**COMMENTS OF THE COUNCIL OF INDUSTRIAL BOILER OWNERS**  
**on**  
**EPA Proposed Reconsidered Rule**  
***Commercial and Industrial Solid Waste Incineration Units:***  
***Reconsideration and Proposed Amendments***

**EPA-HQ-OAR-2003-0119**  
**76 Fed. Reg. 80452**

February 21, 2012

**Figure 1. Typical Biomass Fly Ash Particle Size Distribution<sup>4</sup>**  
Note: Fly-ash means products of combustion

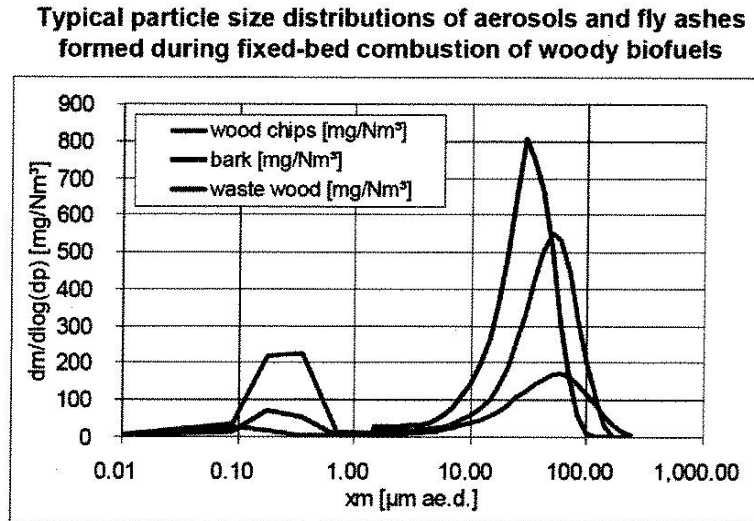
As fuel and fuel mixes vary, particle size distributions generated vary significantly. Biomass combustion emission distributions are characterized by a bimodal particulate distribution.<sup>12</sup>

This is due to the vaporization of volatile ash species in the wood-like potassium and sodium biomass ash that yields a bimodal characteristic with peaks of nominally 0.5 and 20 to 40 microns. Coal ash, on the other hand, tends to exhibit a more mono modal distribution without the submicron peak. Data available for PM CEMs effective is primarily limited to coal, and data on how PM CEMS will respond to monitoring biomass emissions is expected to be problematic.
